UNITED STATES PATENT AND TRADEMARK OFFICE

APPLICATION NO.	FILING DATE	FIRST NAMED INVENTOR	ATTORNEY DOCKET NO.	CONFIRMATION NO.
10/799,143	03/11/2004	Lutz Biedermann	60899 (70301)	7913
44023	7590	02/23/2006	EXAMINER	
BARLEY SNYDER PO BOX 1559 LANCASTER, PA 17608-1559			KIM, JOHN	
			ART UNIT	PAPER NUMBER
			3733	
DATE MAILED: 02/23/2006

Office Action Summary	Application No. 10/799,143	Applicant(s) BIEDERMANN ET AL.	
	Examiner John Kim	Art Unit 3733

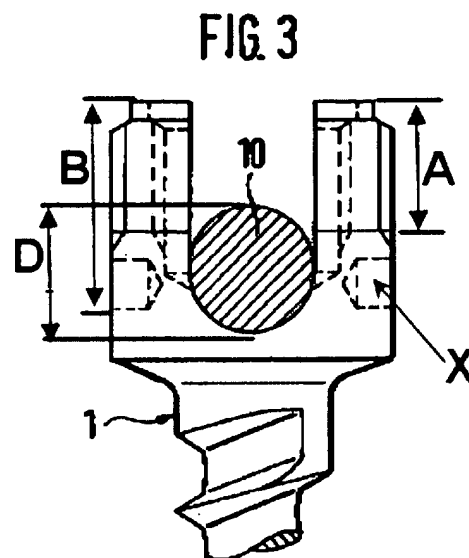
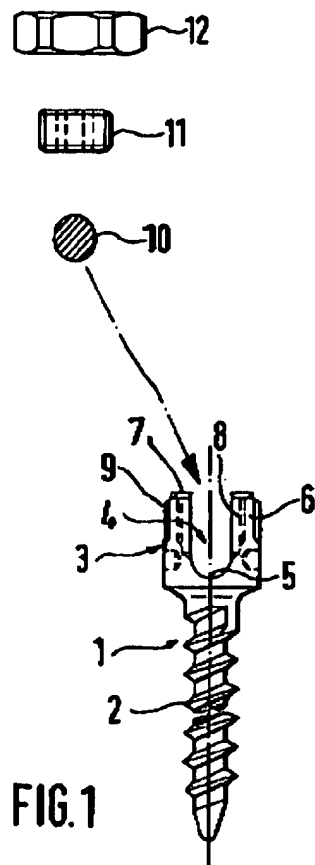
Claims 1-5, 7, 8, and 21 are rejected under 35 U.S.C. 103(a) as being unpatentable over Harms et al. (US Pat 5873878).

Harm discloses the claimed invention, having a shaft (2), a receiving part (3) that holds a rod (10) in a channel and has two legs (6, 7) and a first thread (8 or 9), a securing element (screw member or screw nut) (11 or 12) with a second thread, and an undercut (X in modified figure below) with an edge and a distance B (claim 1, 3, 4, 5, and 21). Harm further discloses of having the invention with the undercut's depth at least the depth of the thread (claim 2), the connection between the shaft and receiving part is a monoaxial connection (claim 7), and the shaft and receiving part are an integral part (claim 8). Harm discloses the claimed invention except for having the distance A between the exterior end surface and the closest portion of the rod. It would have been an obvious matter of design choice to have a distance A, since such a modification would have involved a mere change in the size of a component. A change in size is generally recognized as being within the level of ordinary skill in the art. In re Rose, 105 USPQ 237 (CCPA 1955).
